# PD Modification Application: PRS 22-1487

BOCC Land Use Meeting Date: 01/10/23

Request: Minor Modification to PD

The request is for a minor modification to remove Folio 44659.0000 from PD 87-0083 and all other entitlements are to remain unchanged. The area to be removed is part of a concurrent PD rezoning request (PD 22-0562) to consolidate the 2.37-acre parcel with contiguous properties to the north of said parcel for a separate development project. There are no other changes requested to this Planned Development and all entitlements relating to Folio 44660.0000 are to remain.

### 2.4 Proposed Site Plan (partial provided below for size and orientation purposes. See Section 8.2 for full site plan)

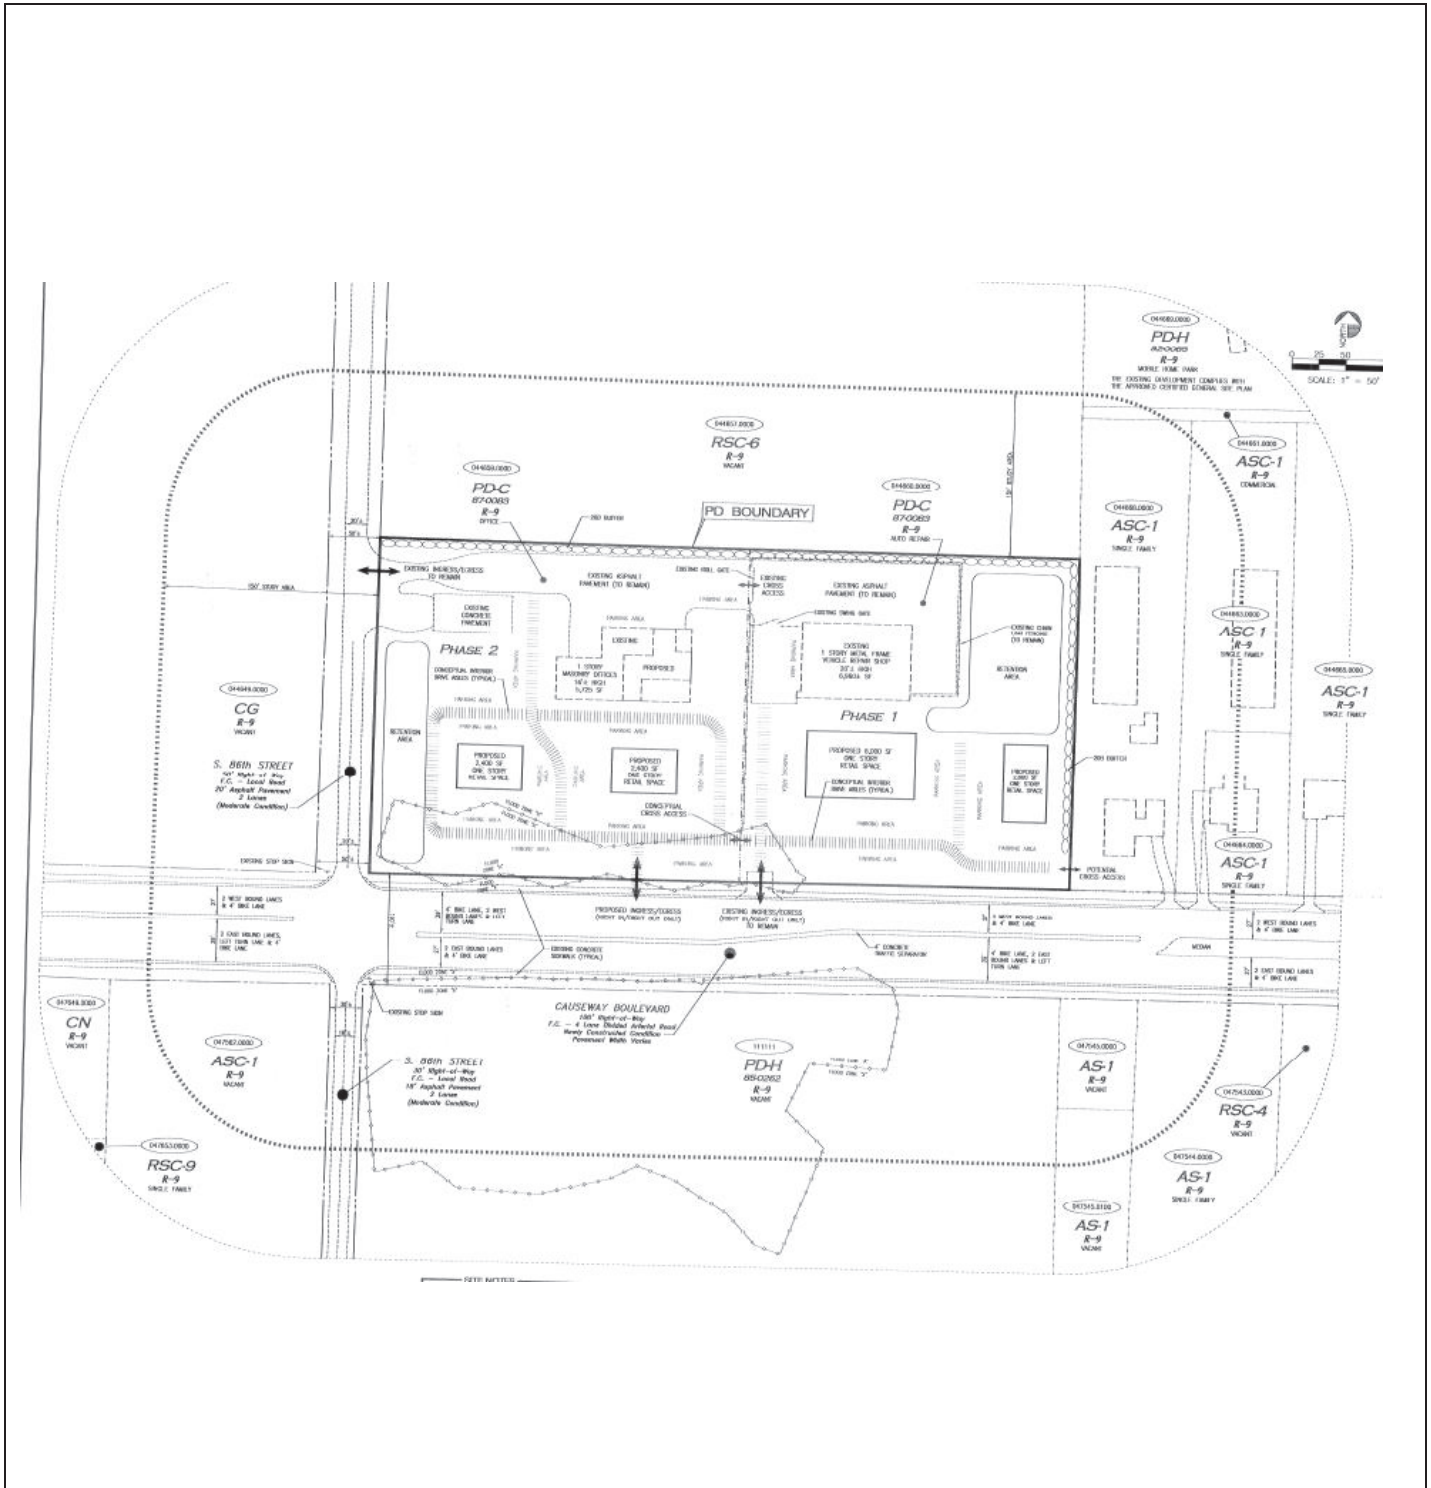
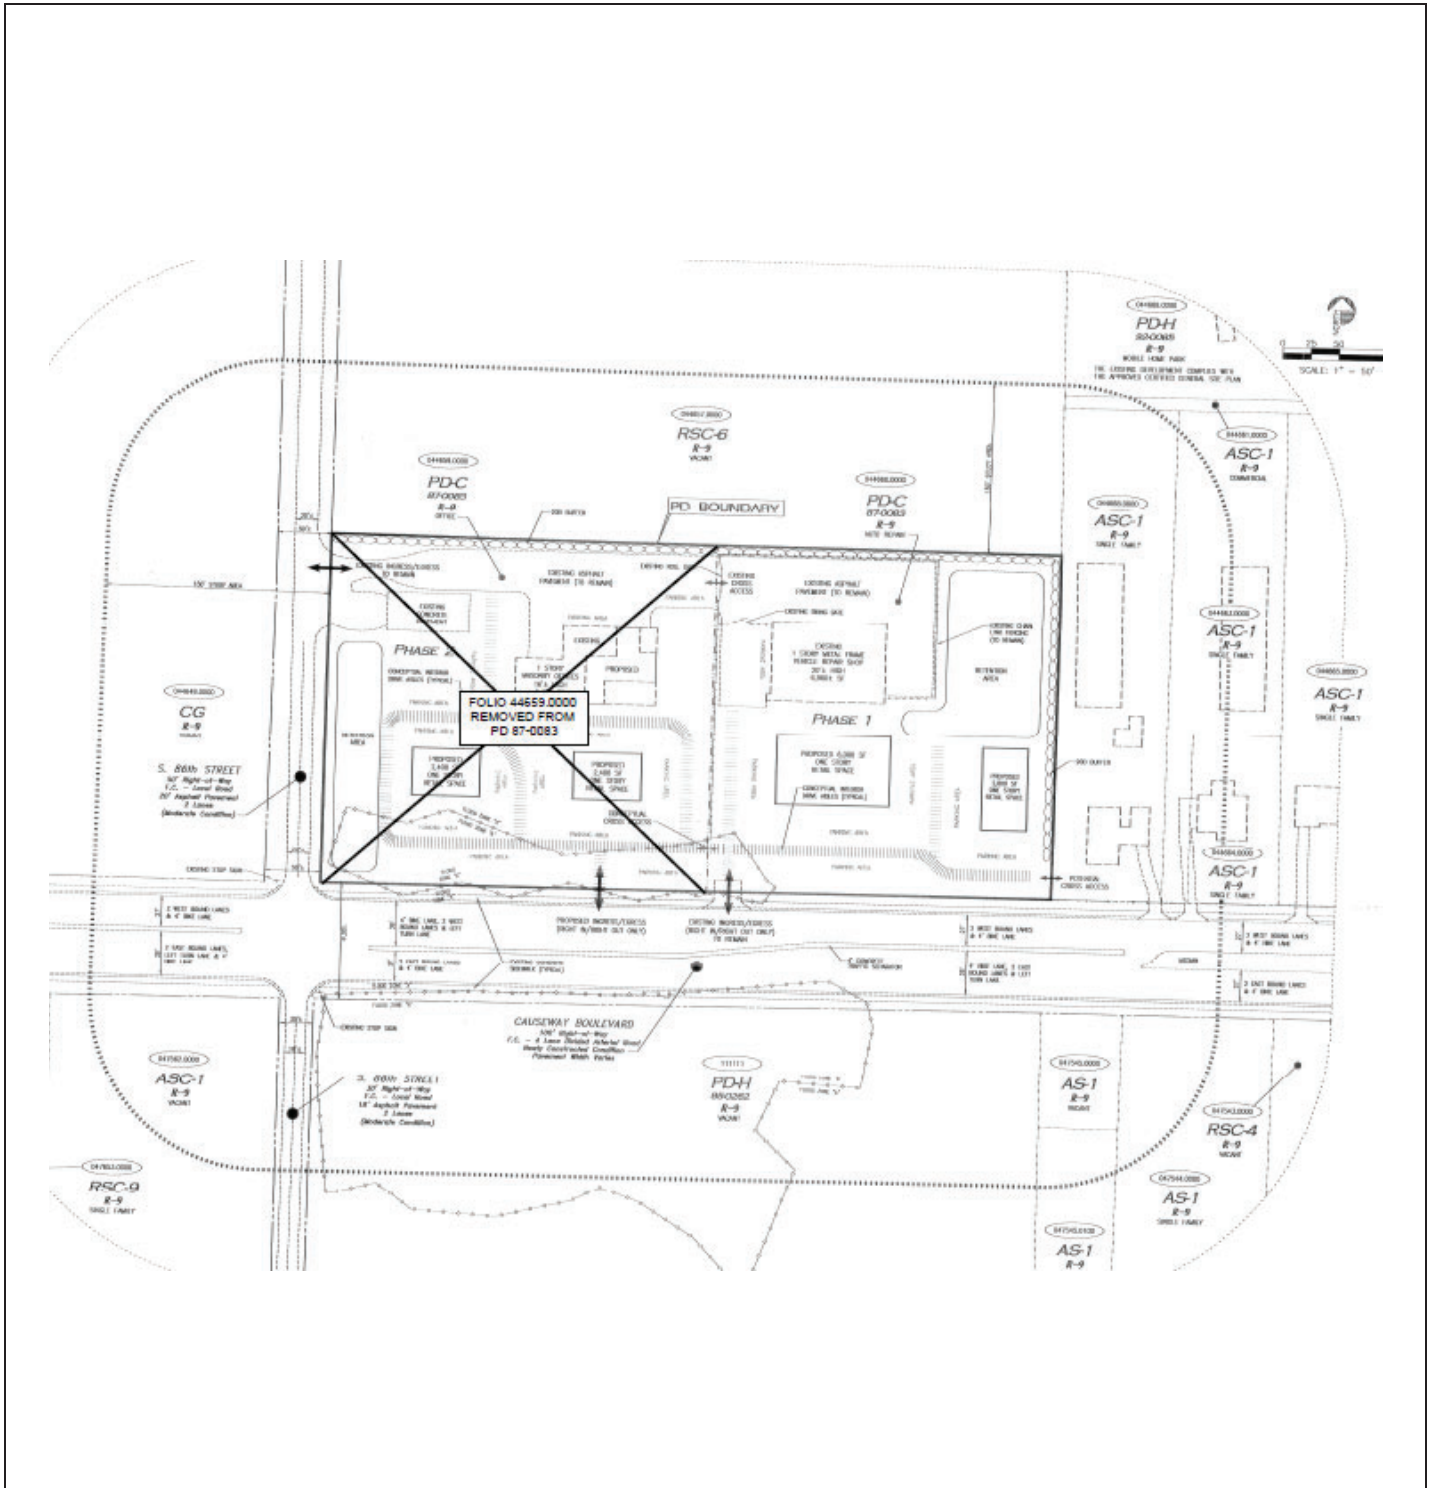
The approved PD is served by an existing restricted right in/right out access connection to Causeway Blvd. and an existing full access connection on S. 86<sup>th</sup> St. The PD modification does not propose to change the access connections. While the remaining area within the PD will no longer have direct access to S. 86<sup>th</sup> St. as a result of the removal of folio# 44659.000, vehicular and pedestrian cross access is required.

- Notwithstanding anything shown on the site plan or contrary to the conditions of approval herein, vehicular and pedestrian cross access shall be applied consistent with the County Land Development Code requirements.
